## Jackson County Board of Commissioners

Date: April 20, 2022

### **RE: Addendum 4 to Jackson County ITB 220011, Runway and Taxiway Pavement Rehabilitation, Jackson County Airport**

MILLING & LEVELING CROSS-SECTION DETAIL

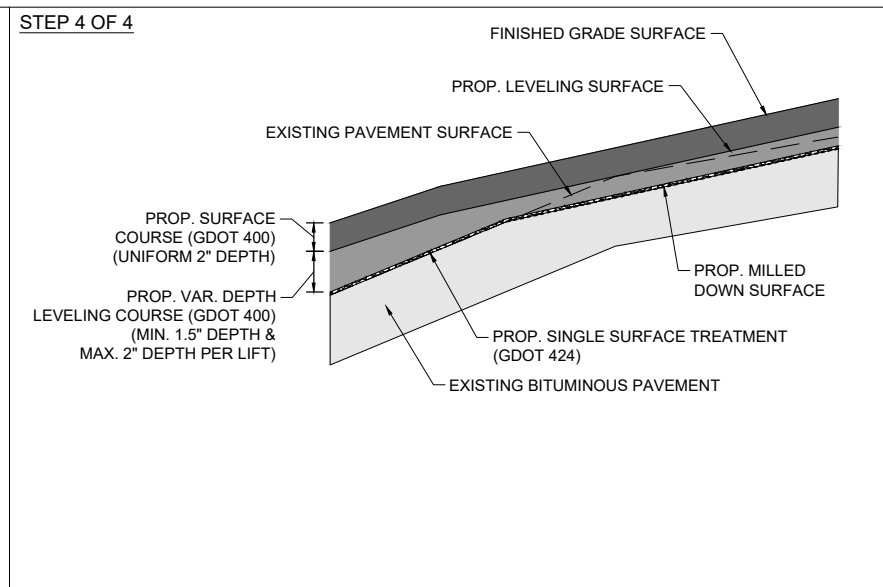
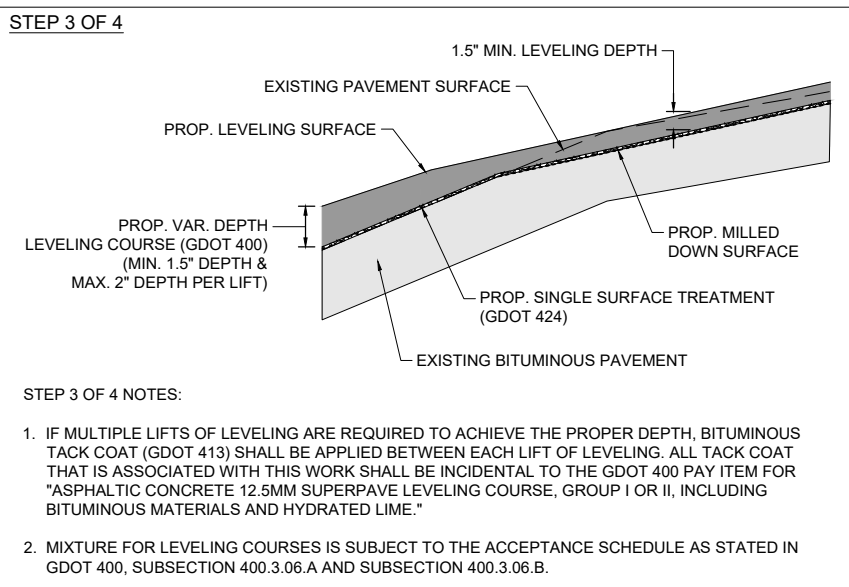
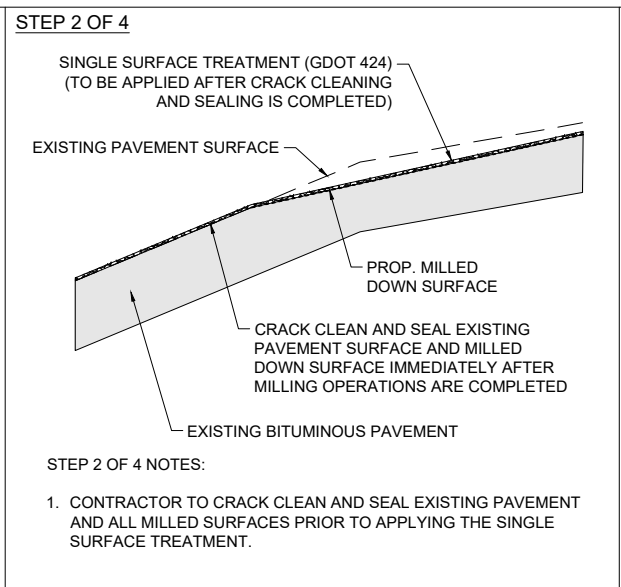
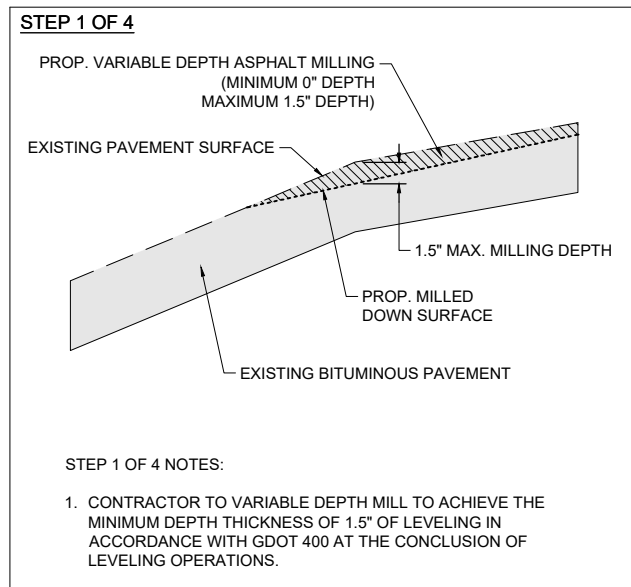
2. Sheet C45.1: ADD detail number 4/C45.1 titled “Milling and Leveling Cross-Section Detail”. Please see attached for the detail.
3. REVISE detail 5/C47 “Airfield Lighting System Adjustment Notes”. Revisions to these notes presented in this addendum are shown in **bold text**.

1. SEE THE "PAVING NOTES" IN DETAIL 1/C45 ON SHEET C45 FOR A DETAILED DESCRIPTION OF THE SEQUENCE OF CONSTRUCTION FOR AREAS THAT ARE TO RECEIVE LEVELING COURSE.
2. THIS DETAIL IS A CONCEPTUAL REPRESENTATION OF HOW THE VARIABLE DEPTH MILLING AND LEVELING IS TO BE CONSTRUCTED AND IS NOT INTENDED TO REPRESENT SPECIFIC DESIGN OR FIELD CONDITIONS.
